SERVICE BULLETIN

Date: MARCH 10, 2008
Log Number: 113
Model Affected: GL-X
Subject: TIMER SPLASH SHIELD PN# 00408.71

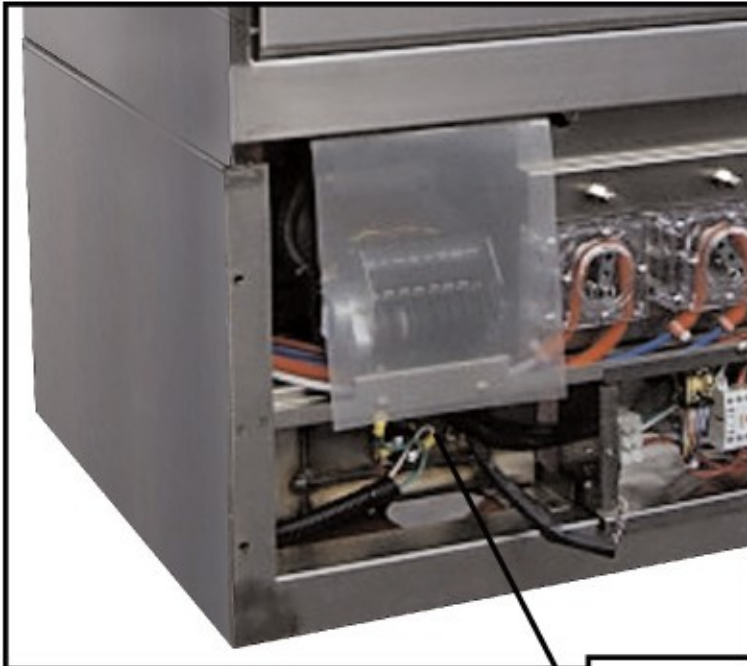
The GL-X has been retrofitted with a *"Timer Splash Shield"* to minimize moisture contact with the mechanical cam timer. Installing *"Timer Splash Shield"* gives additional assurance that the electronics **"will not"** be subjected to moisture, and will prevent service related issues.

The GL-X *"Timer Splash Shield"* PN#00000.00 can be ordered for field retrofit. The shield will be provided with a double back tape for easy installation.

It is recommended you order and put into place this preventive protection shield. CMA recommends installing this shield on all GL-X Glasswashers in the field. CMA will supply at no charge if ordered with-in the next 60 days.
